Application for a Certificate of Appropriateness

ADDRESS OF PROPERTY	<i>824 Lexington Avenue, Dilworth Local Historic District</i>	<i>HDC 2012-064</i>
SUMMARY OF REQUEST	<i>Addition</i>	
OWNERS	<i>Michael & Laura Glaser</i>	
APPLICANT	<i>Michael Glaser</i>

This application requests approval of a rear addition with two features that are wider than the existing structure.

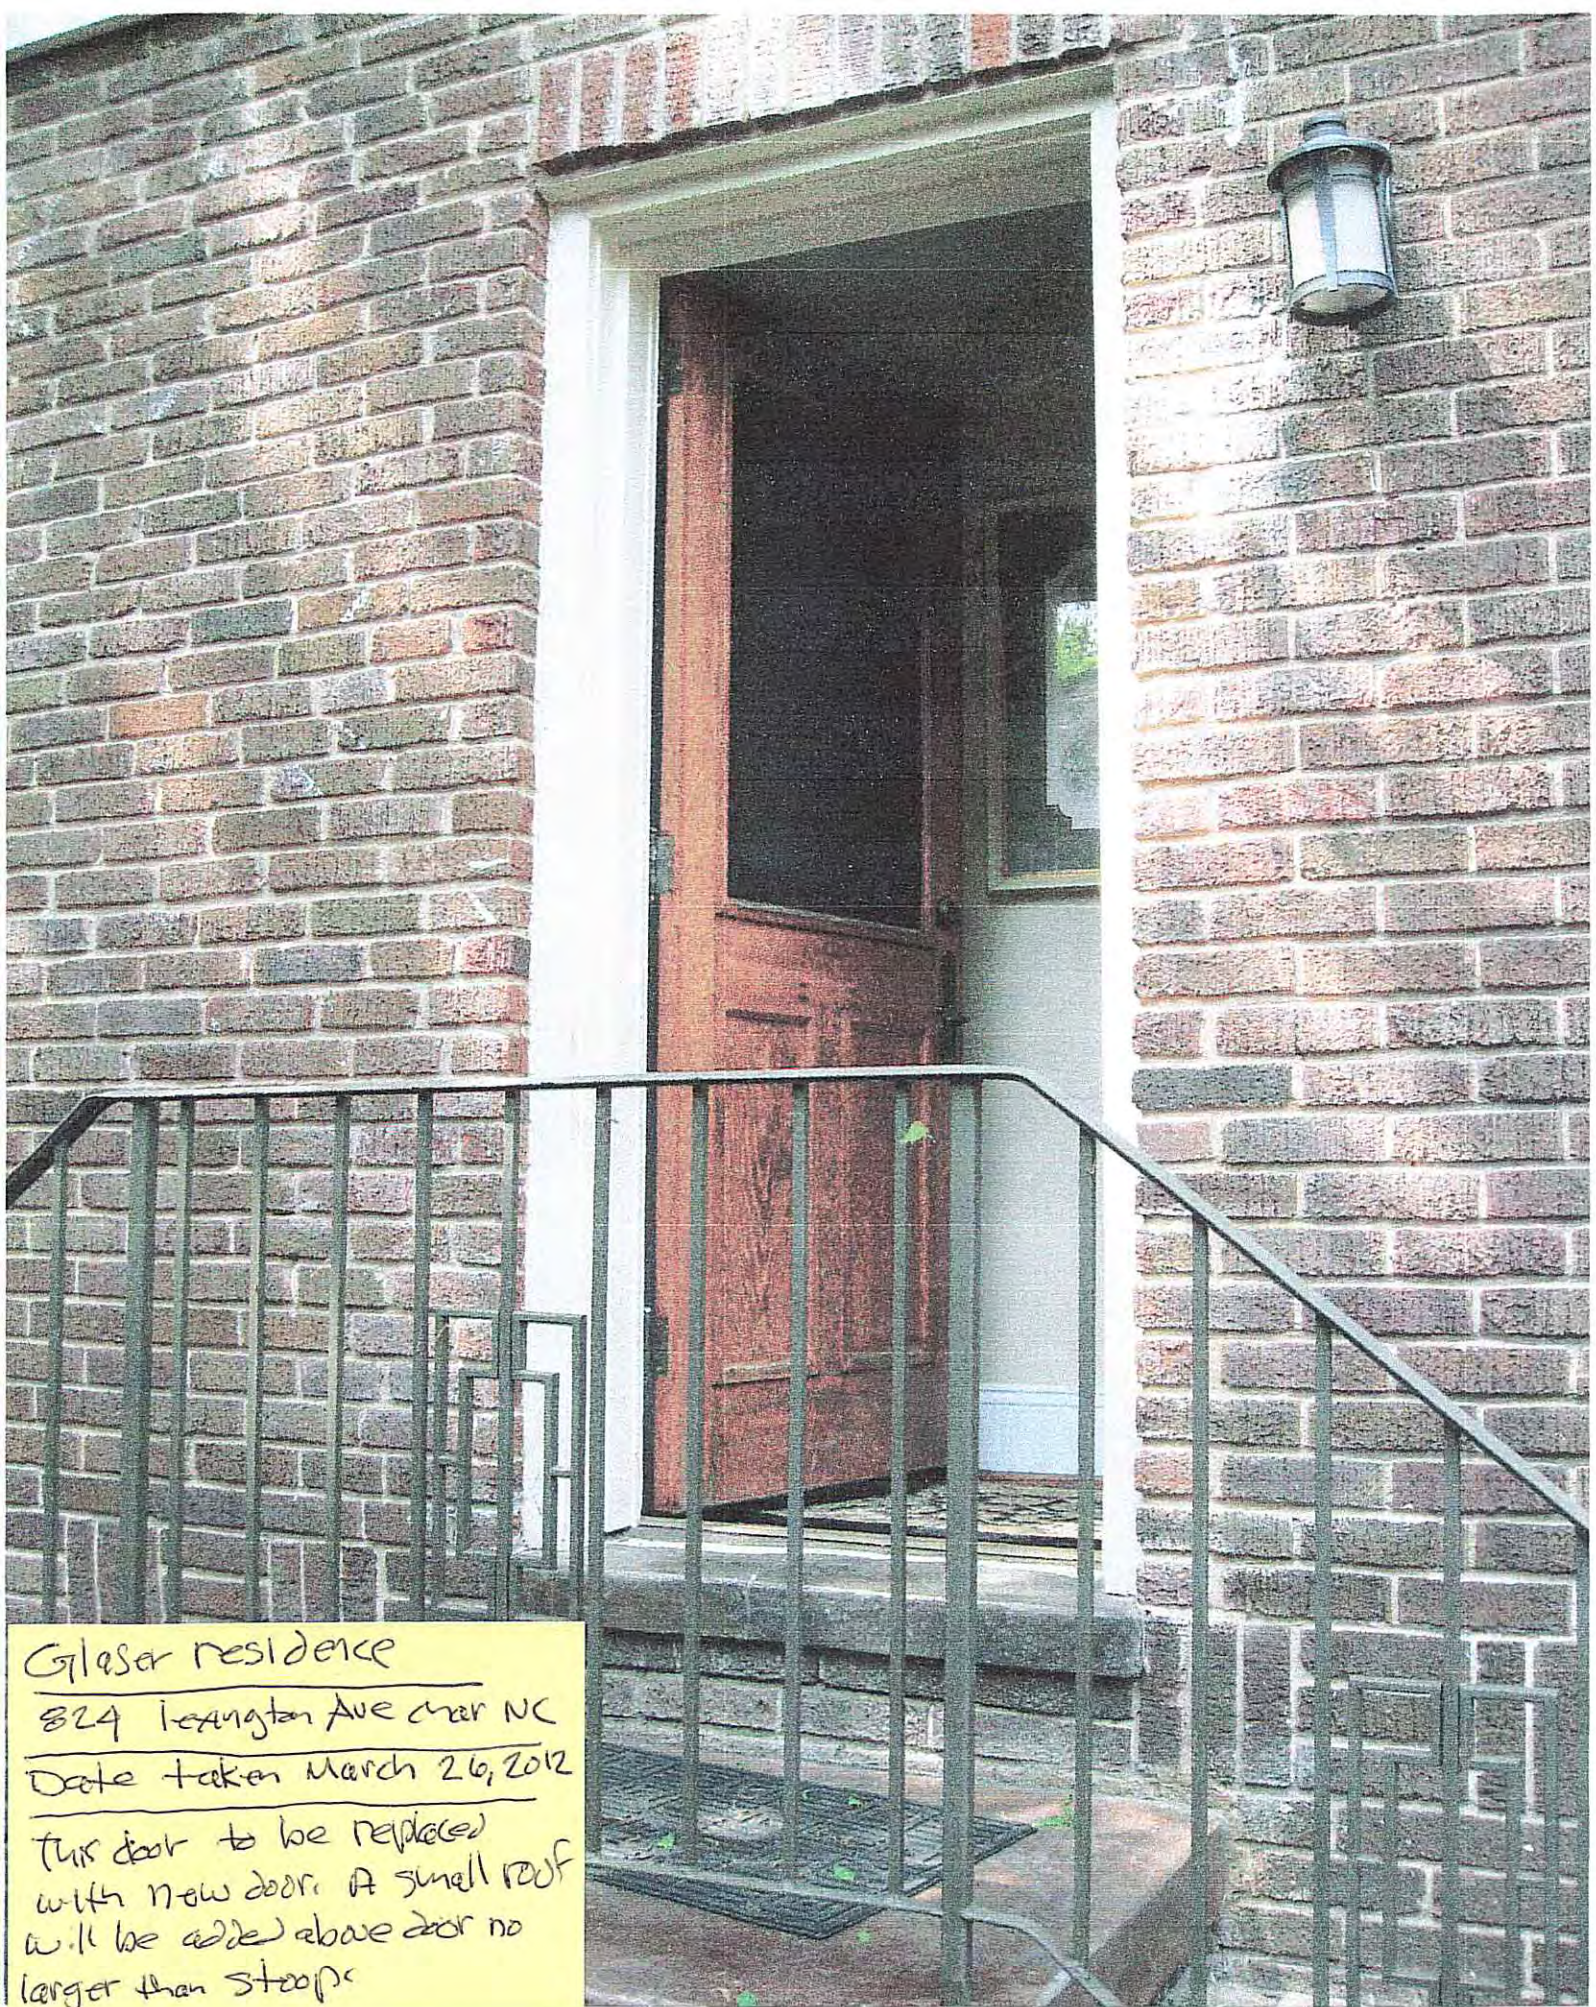
Addition to rear - 8' extension
into yard. New chimney to left
side (side yard). Small roof to
right side (side yard)

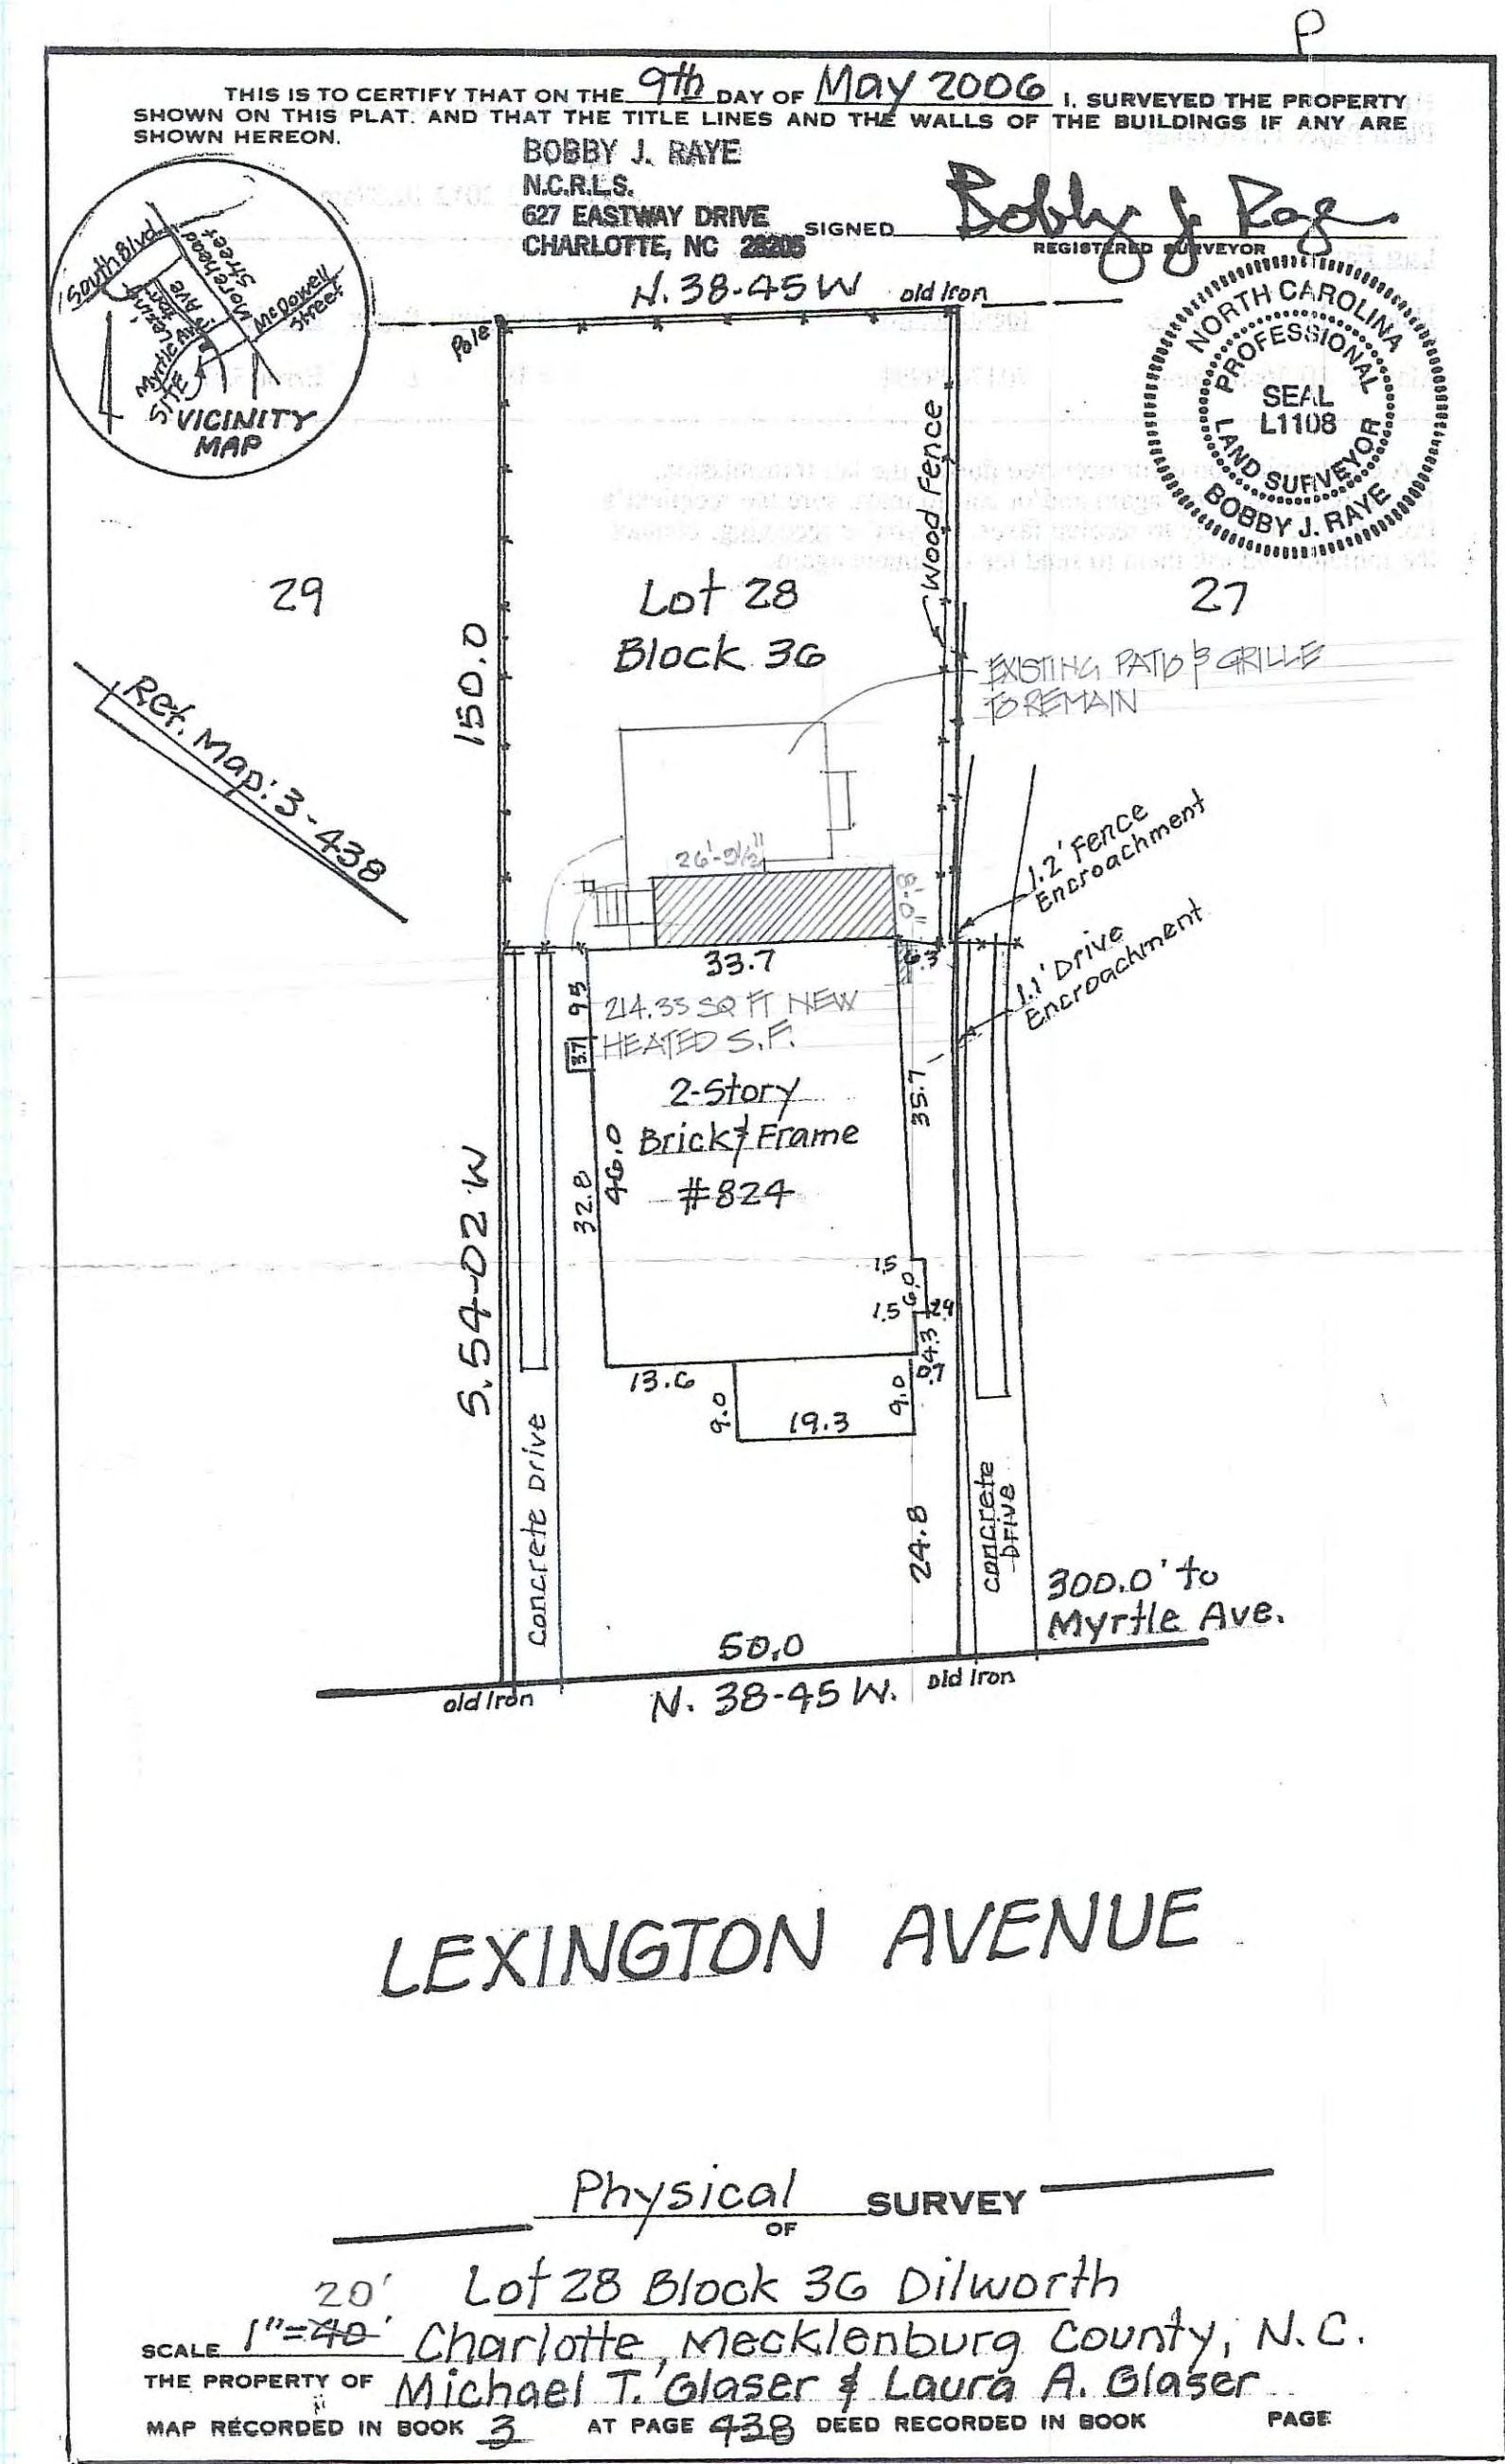
This door to be replaced
with new door. A small roof
will be added above door no
larger than stoop
